Attached is a copy of a report dated February 17, 1988, from the Federal Emergency Agency (FEMA) evaluation of the Waterford 3 Steam Electric Station alert and notification system. The FEMA representatives conducted a system engineering design review and a telephone survey of persons living in the vicinity of the Waterford 3 site. The attached document titled "Waterford 3 Steam Electric Station Site Specific Offsite Radiological Emergency Preparedness Alert And Notification System Quality Assurance Verification " concluded that there was reasonable assurance that the system was adequate to promptly alert and notify the public in the event of a radiological emergency at the site. The Honorable Buddy Roemer, Governor of Louisiana, has been advised of the approval.

The Federal Emergency Management Agency (FEMA) has completed an analysis of the prompt alert and notification system for the Waterford III Steam Electric Station located in Taft, Louisiana. This review has been completed pursuant to Title 44 CFR, Part 350; selected evaluative criteria and Appendix 3 in NUREG-0654/FEMA-REP-1, Revision 1; and FEMA-REP-10, the "Guide for the Evaluation of Alert and Notification Systems for Nu

COMPARATIVE RESULTS, SHADOW ZONE (w/5000 SIREs)

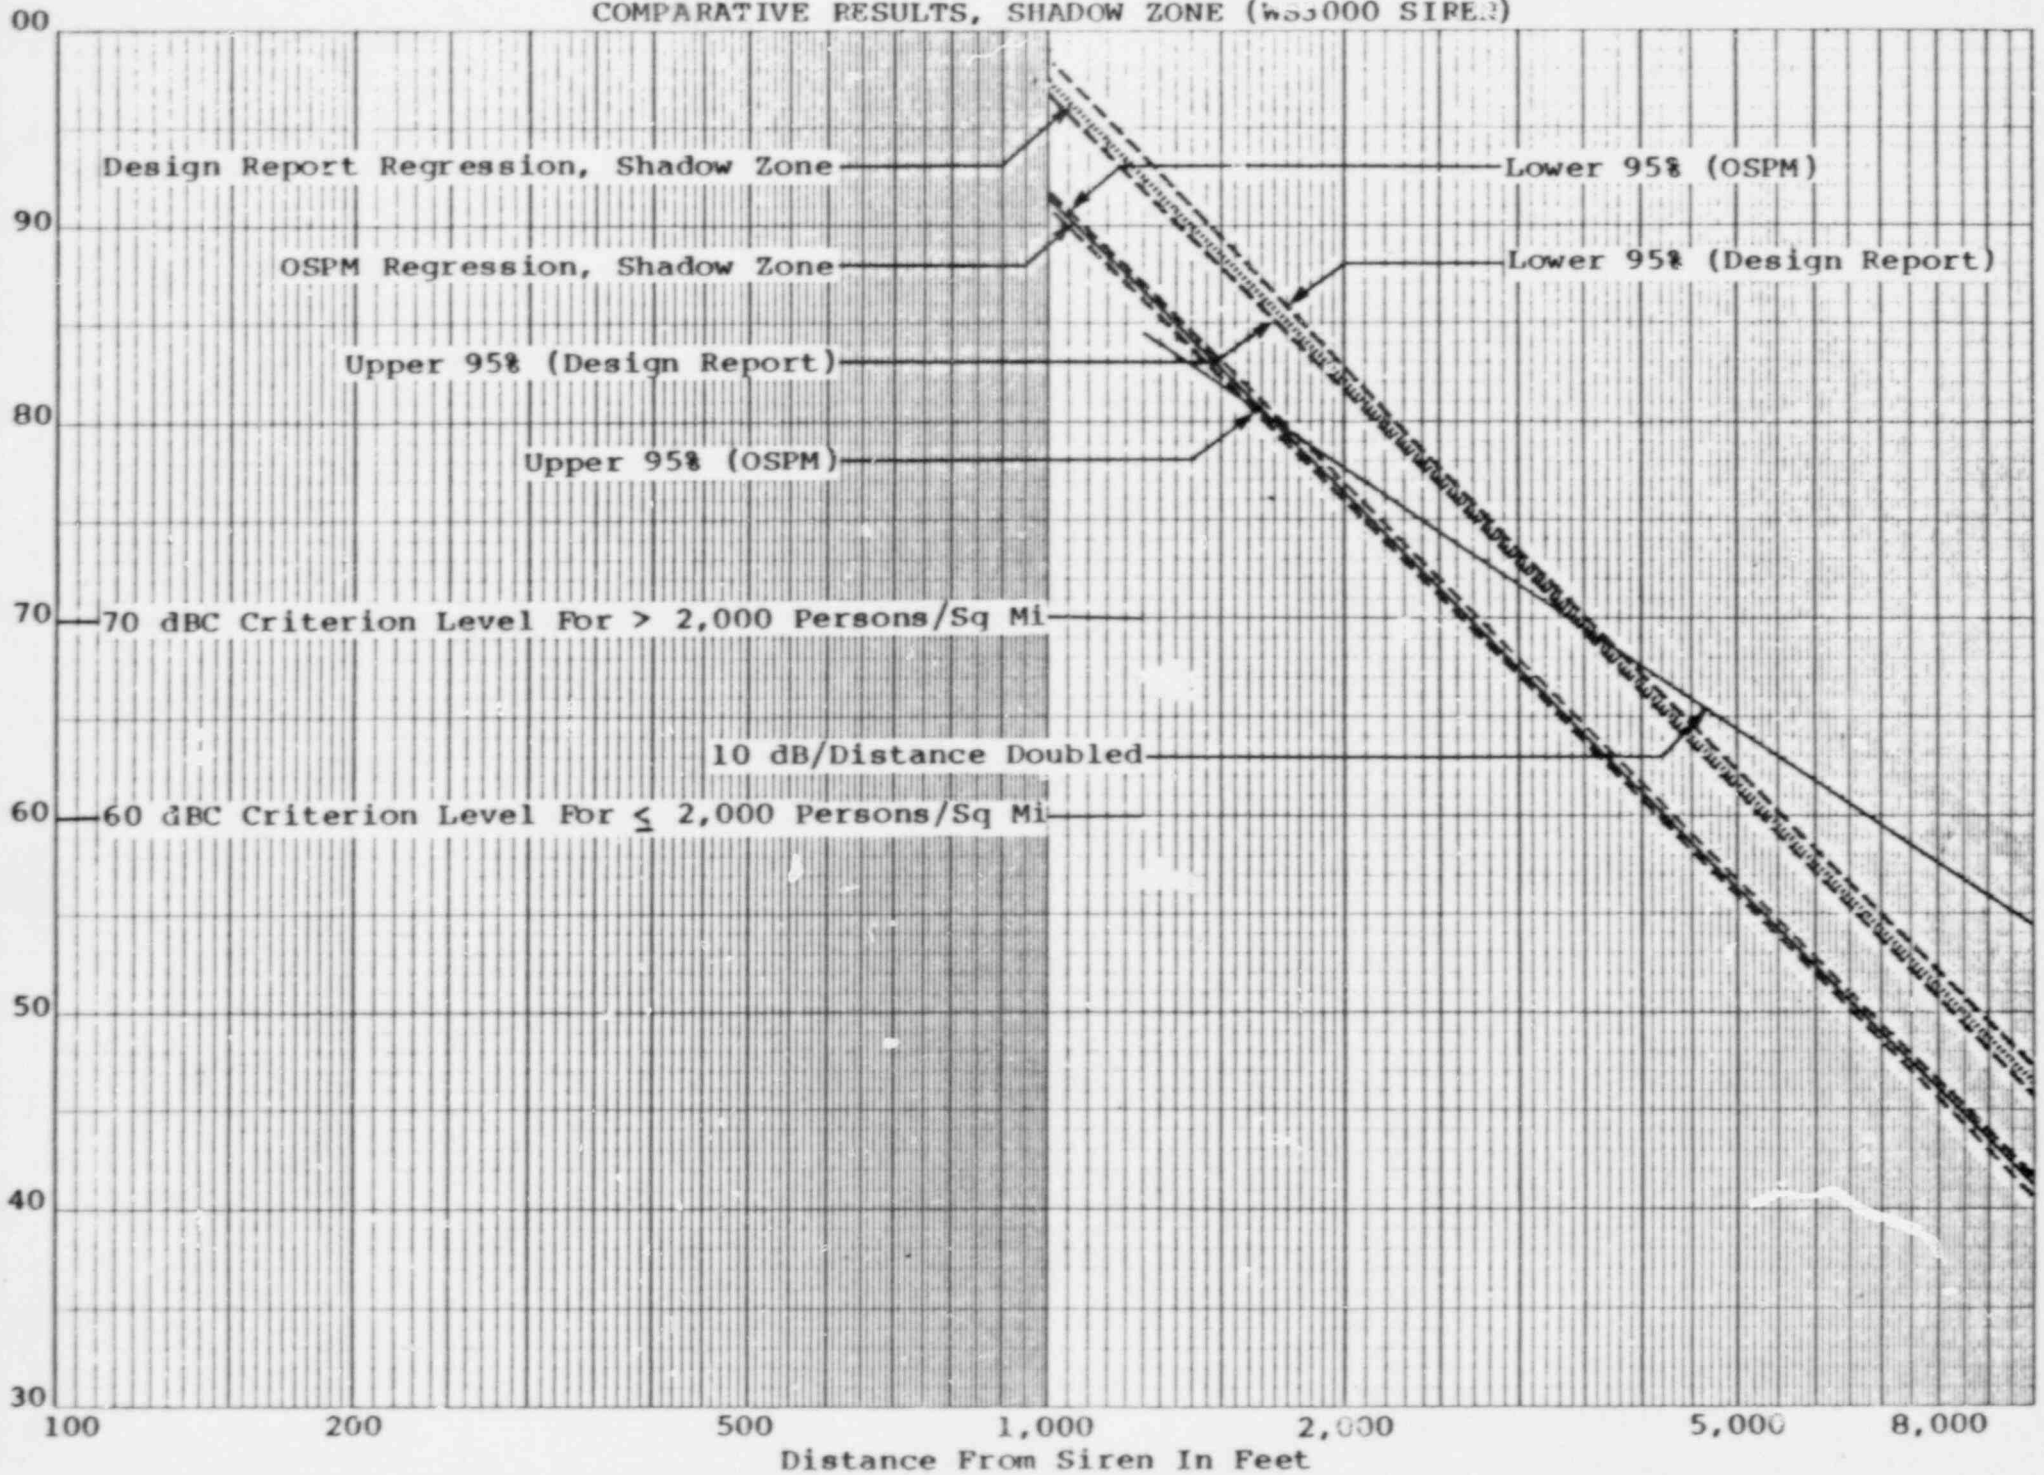
Figures 3 through 6 of this report depict the regressions of OSPM predictions and the Design Report's predictions, along with the 10 dB loss per distance doubled attenuation rate, for each of the four categories. Some general comparative observations can be made. First, the regressed ranges for 70 and 60 dBC based on the Design Report's data are almost identical with those of OSPM predictions over the rolling and flat terrain categories, which are the predominant terrain types in the area. The linearized attenuation rate within the range of 1,000 to 10,000 ft is approximately 12 dB for OSPM results and 15 dB for Design Report results, both substantially higher than the 10 dB per distance doubling rate. This is largely due to the relatively high operating frequency (800 Hz) of the WS-3000 sirens which results in much higher air absorption losses than anticipated by the 10 dB rule (which is applicable to sirens operating at around 500 Hz in the absence of special conditions). Second, the OSPM results show much larger 70 and 60 dBC ranges for propagation paths over water, as expected. Last, the 60 and 70 dBC ranges estimated by the licensee are liberal over the shadow zone category.
